Engineer's Stamp dated 2-14-11 (D17/D048) REDW Headquarters, 7425 Jefferson NE **Grading and Drainage Plan**

Re: REDW Headquarters, 7425 Jefferson St NE,

Re: REDW Grading and Drainage Plan and Drainage Management Plan Engineer's Stamp dated 2-9-11 (D17/D048)

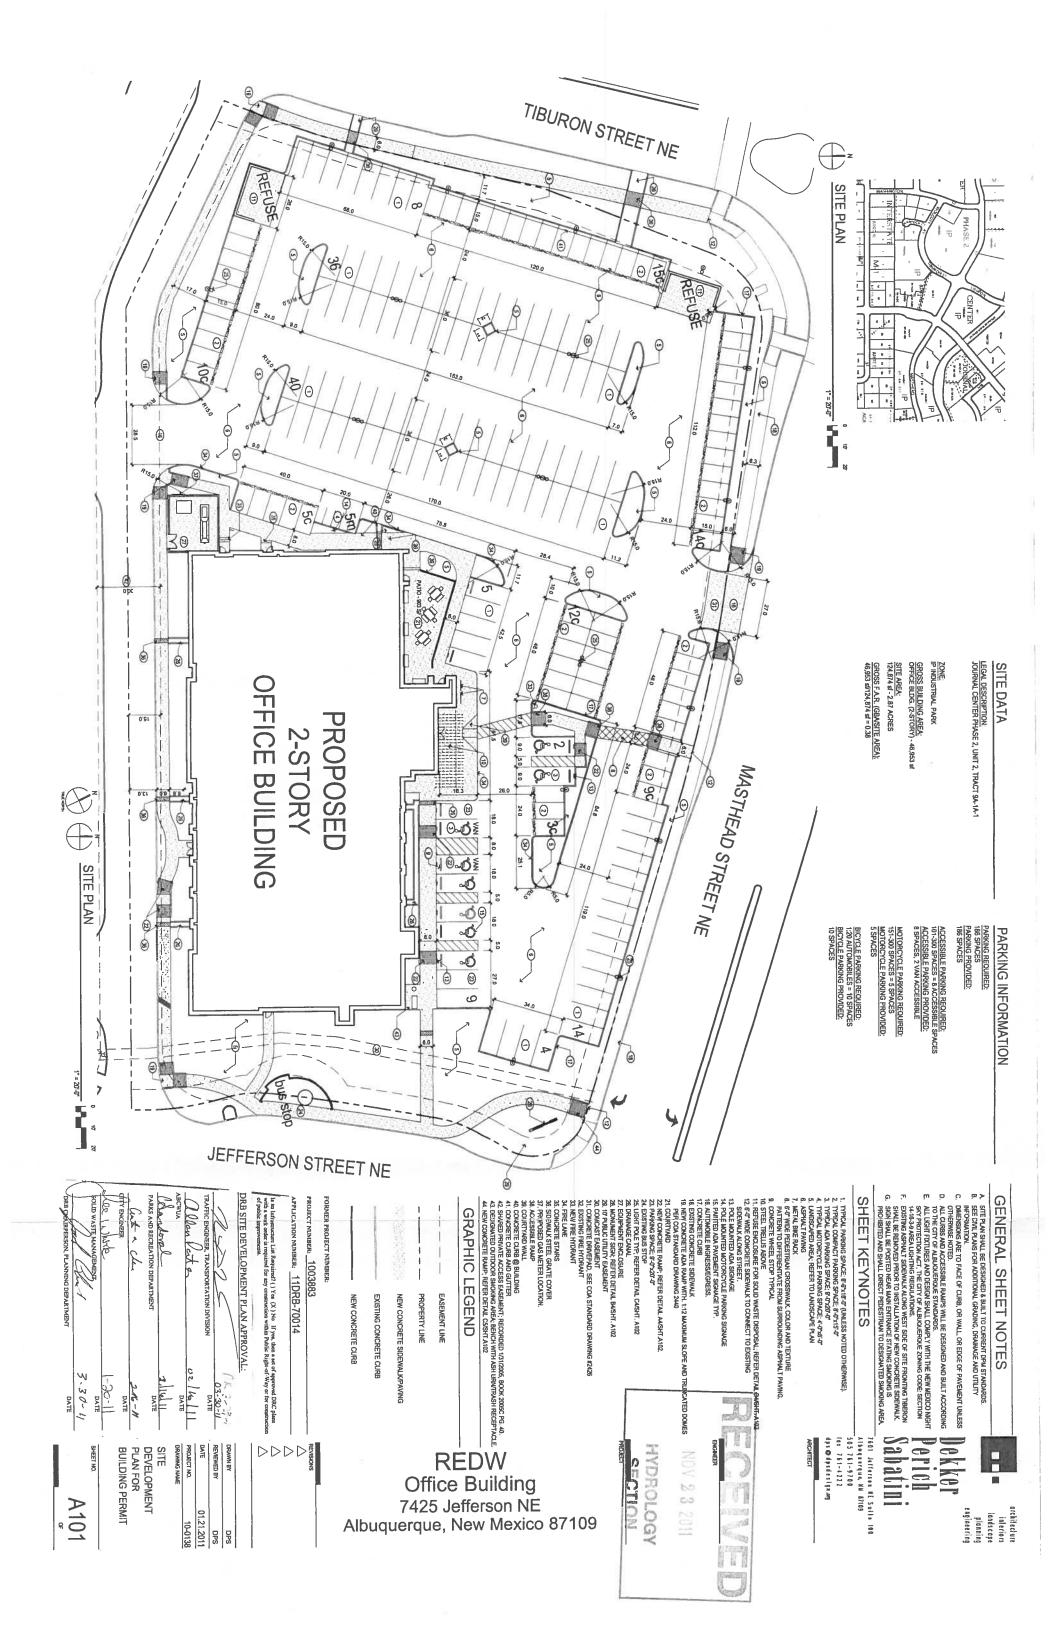
Kurt and I went out to look at the intersection of Tiburon & Washington. The high point is at the intersection. We also looked at the roundabout grading. Any surface drainage that enters the south side of Masthead will flow south into Tiburon.

Given what we discovered during our site visit I looked at the big picture drainage to see if there were capacity issues with the street or existing storm drain. The flow in Tiburon splits at Washington because the half street capacity is less than peak flow. I also evaluated the capacity of Rutledge and the inlets in sump at the west end of Unit 1. These both have capacity to accept current peak flow rates and the additional flow from the REDW site. I have attached a markup showing the basin boundaries and flow rates in Tiburon and Rutledge.
